RE: Planning Application # 2017/4366/P Address: 66 Fitzjohns Avenue, London NW3 5LT

I wish to lodge our objection to the proposed application.

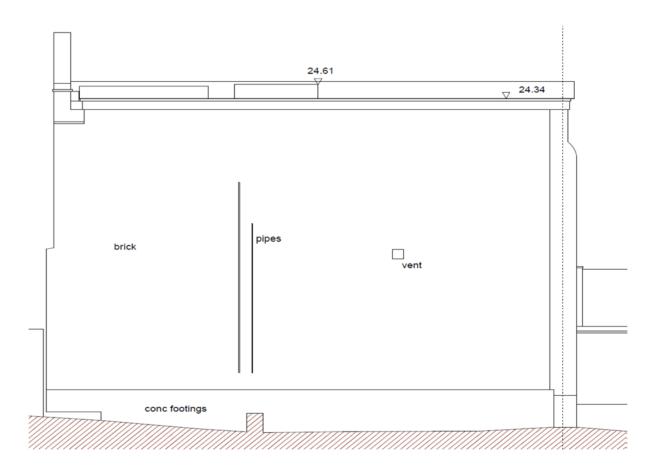
The set back at the rear of 0.2m is not a setback that would be perceptible and certainly would not serve to reduce the bulk as seen from Arkwright Road residences. The additional floor does NOT resemble an attic floor at all as attic roofs are pitched and the proposed is for a full vertical story. The set back has not been consistent by setting back at the sides and therefore the increase in bulk is still very large when viewed from the Arkwright road and #62 Fitzjohn's avenue. Also the side elevation can be clearly viewed from Fitzjohns avenue and the full extra story height will be visible. The long views from Fitzjohns Avenue also render the 2.5m set back useless and the full bulk is visible both of the front and side elevation. In such a back land site all elevations should be set back as all are viewed directly by neighbours.

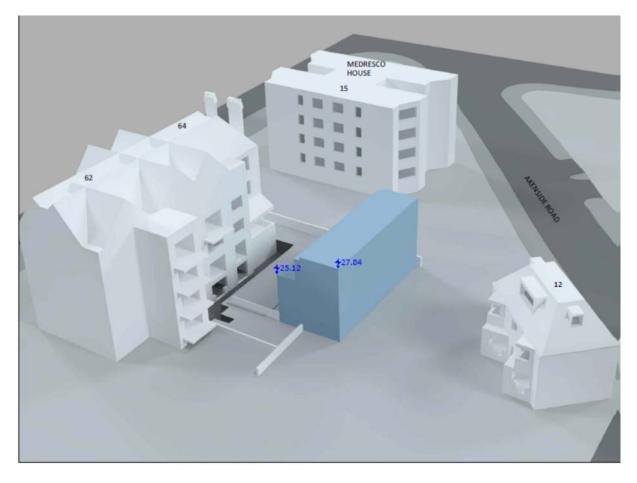
Again the above statement is not quite correct. The 1st floor has inward looking clear glazing but the 2nd floor proposed has outward looking clear glazing on the northern and southern windows. This will allow unacceptable overlooking of the neighbours.

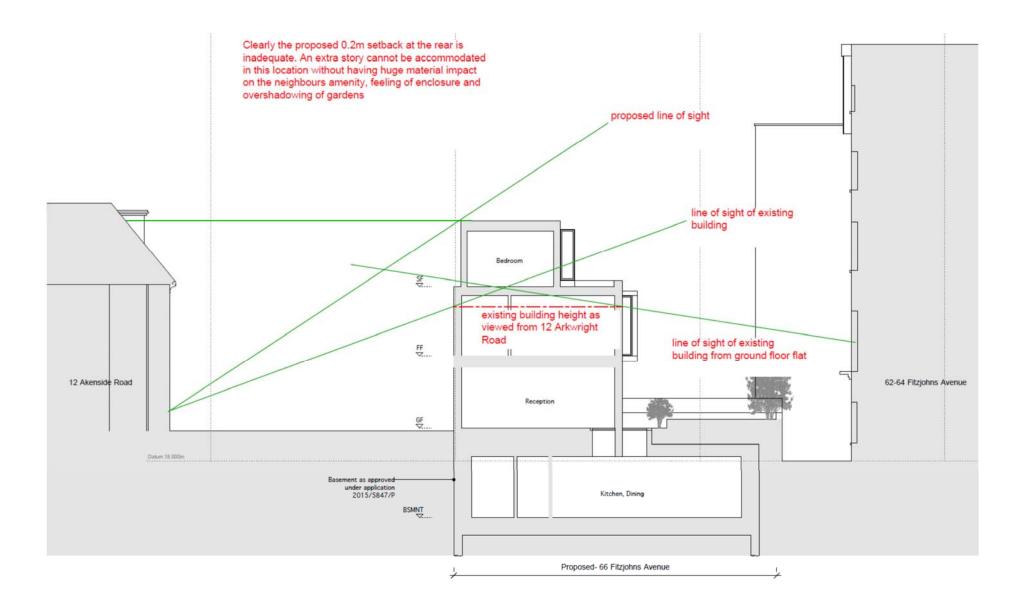
Again the above is conveniently misleading. The actual existing roof level is 24.34m as shown below. The proposed new roof height is 27.84m. This is a 3.5m increase in height from the existing condition. And although the consultants compare this to #64 Fitzjohns Avenue, it is wholly appropriate to compare this height to the building directly behind the site and in close proximity at 12 Arkwright Road. The proposed building will be almost the same height as the building on Arkwright Road to which it should also be subservient. The image below shows also the effect on the sight lines the additional storey will have on the outlook from 12 Arkwright Road. Both these considerations clearly show the inappropriate nature of the proposal
